**CASE SUMMARY SHEET**

**CASE NUMBER: V23-11-40**

**REQUEST: V23-11-40/R23-11-02 – Jason and Ashley Collier request a variance to CLURO Section 7.5.10.3. B-3 Site Development Regulations and to resubdivide Lot D1-B into Lots D1-B-1 & D1-B-2, Old Town of Mandeville, Square 34 Lot D1-B, B-3 Old Mandeville Business District, 426 Lafitte Street**

A Resubdivision of Lot D-1-B, into Lots D1-B-1 & D1-B-2, Square 34, City of Mandeville, St. Tammany Parish, Louisiana

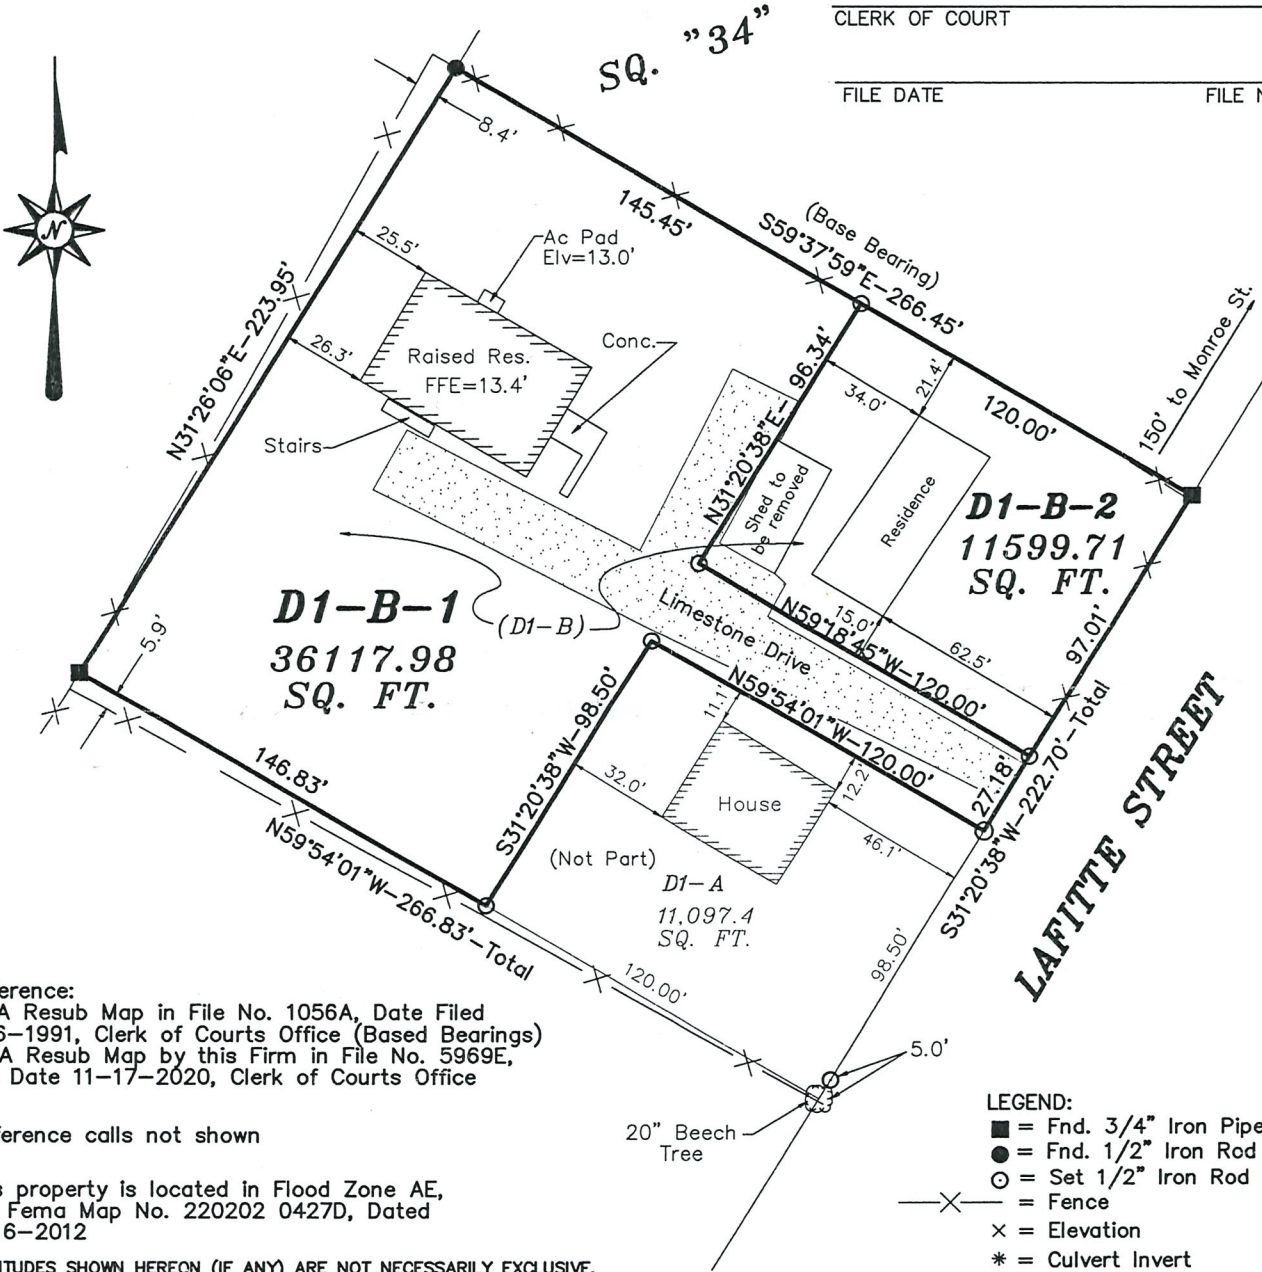
Public Works reviewed the survey and had the following comments: Sewer and water services are already in place for the existing lots. No new services are required.

Sewer and water services are already in place for the existing lots. No new services are required.

**DRAINAGE PLAN**  
SCALE: 1" = 30'-0"

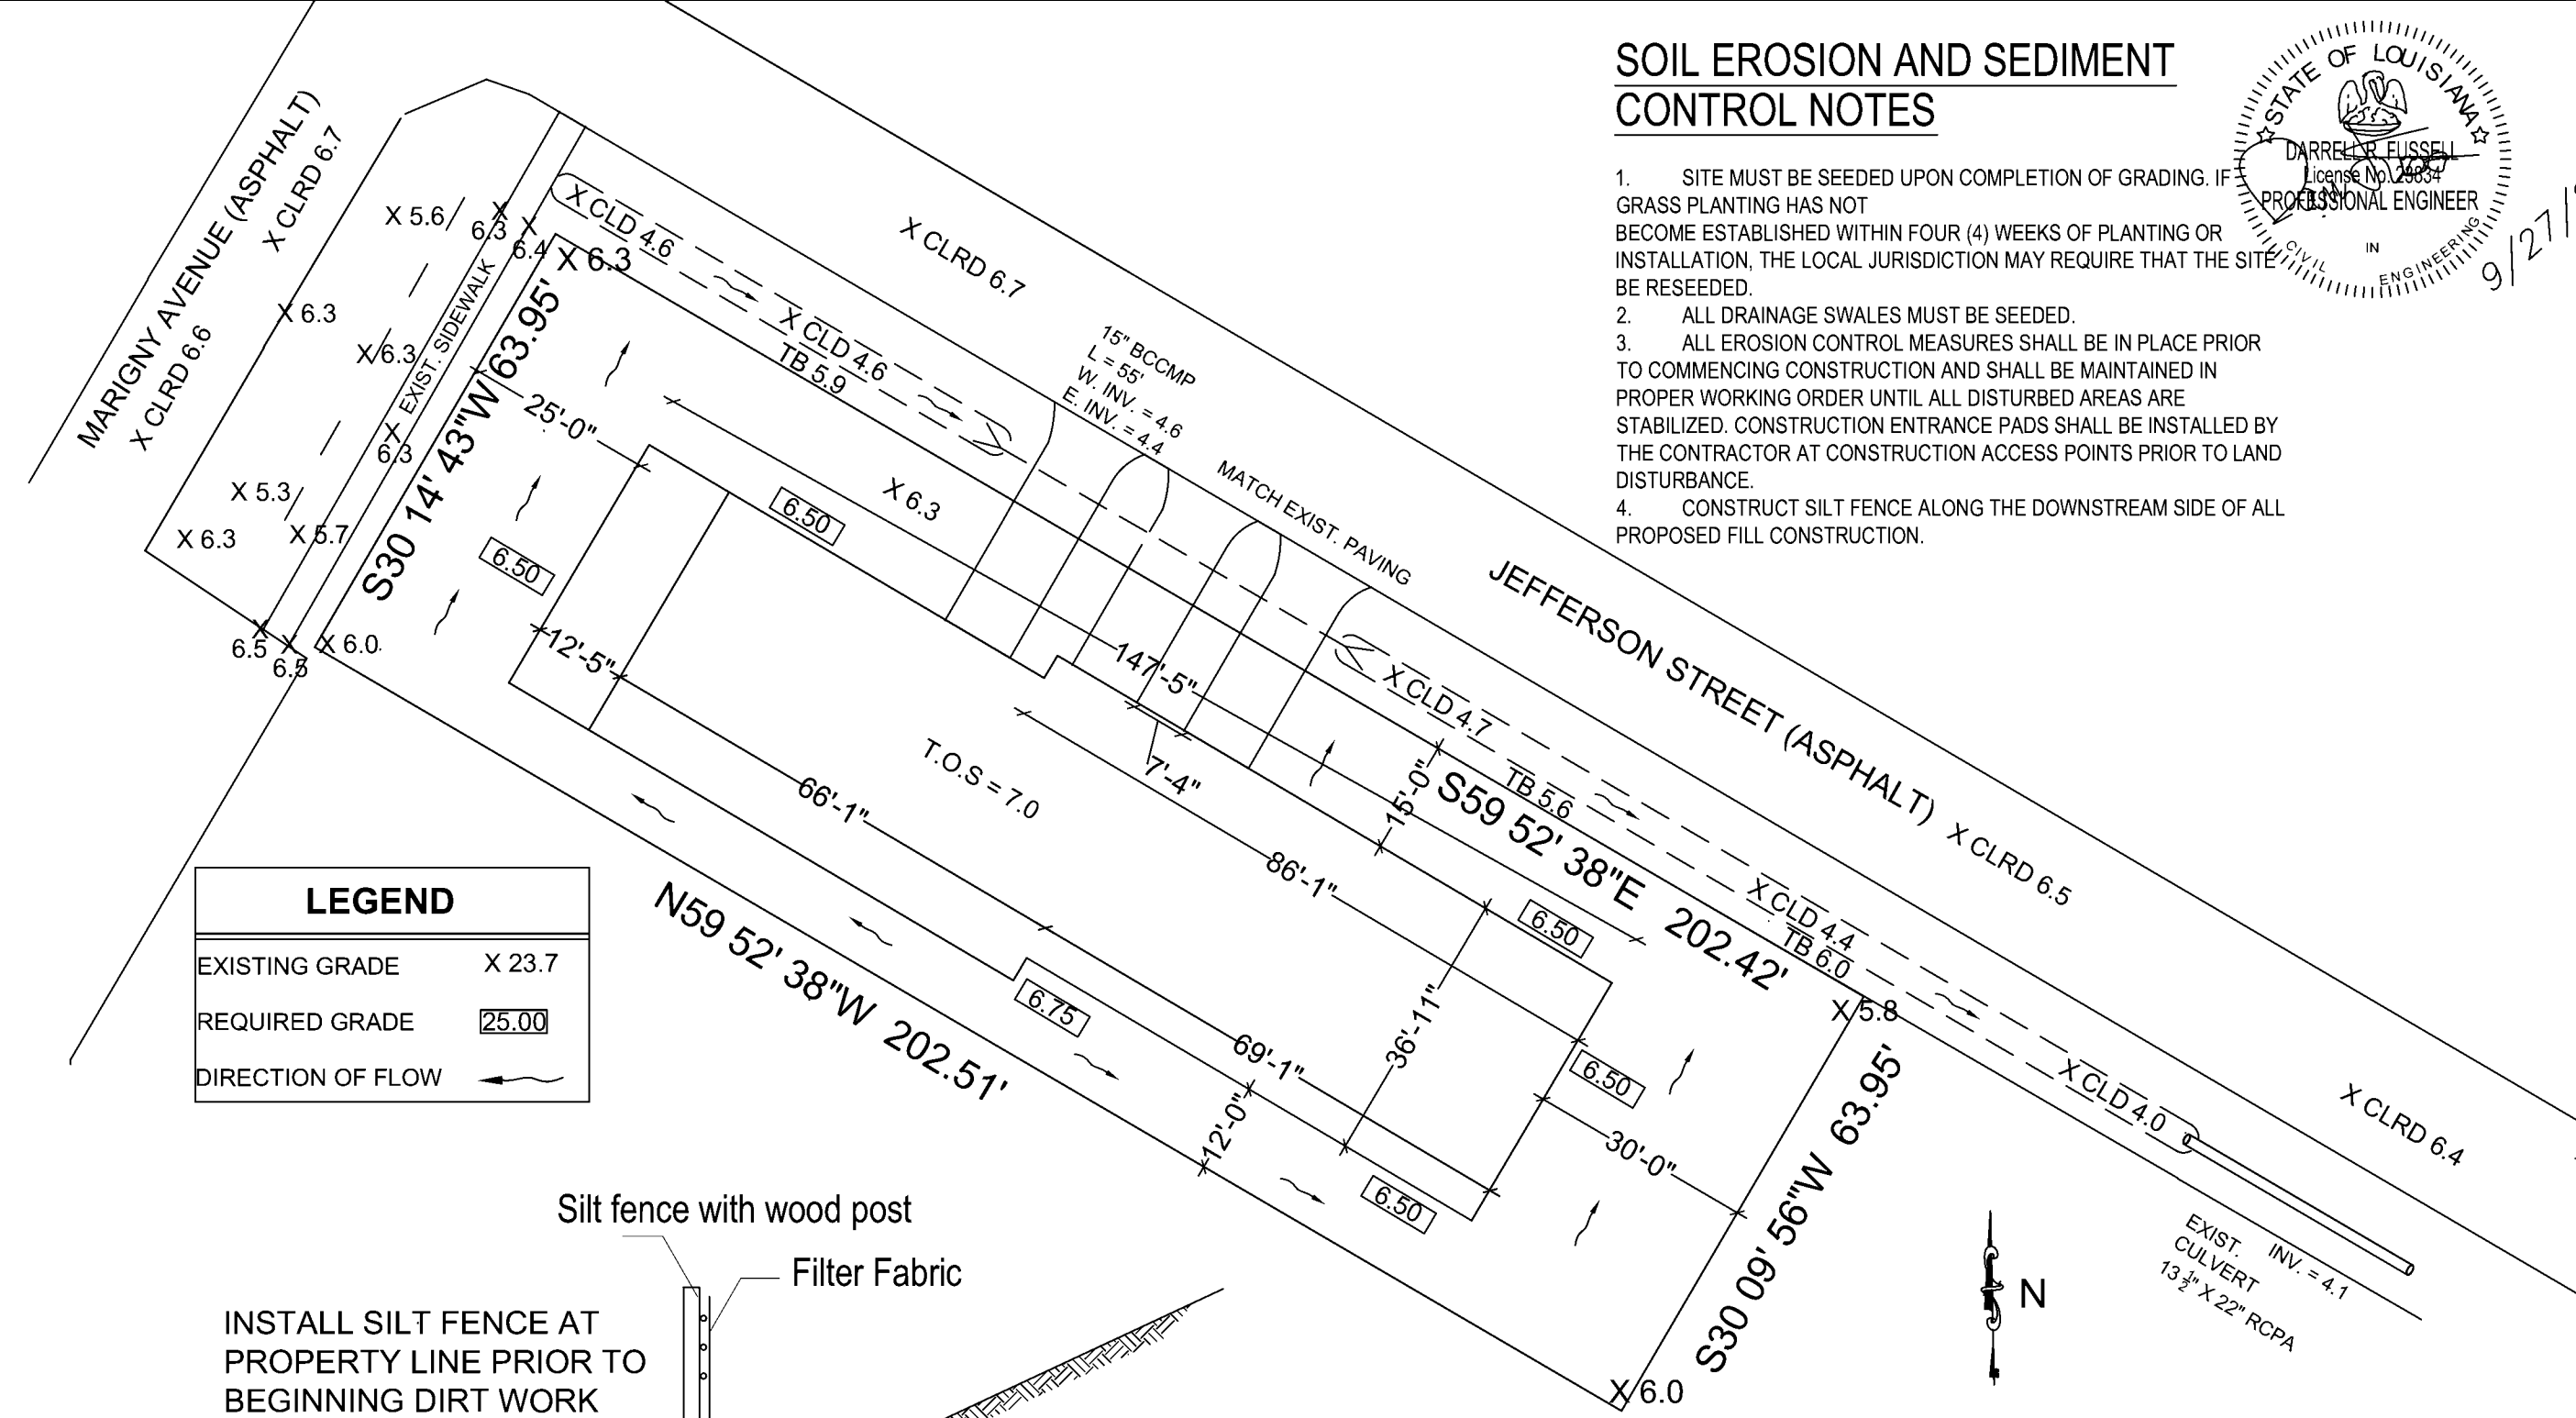
Public works has reviewed the submitted drainage plan and had the following comments. The maximum height allowed by CLURO Sec 5.2.3.2 for the ground level slab would be 6.52. The additional height is minimal and would not have impacts on neighboring properties. The proposed drainage plan would be acceptable if the height variance is granted.

The maximum height allowed by CLURO Sec 5.2.3.2 for the ground level slab would be 6.52. The additional height is minimal and would not have impacts on neighboring properties. The proposed drainage plan would be acceptable if the height variance is granted.
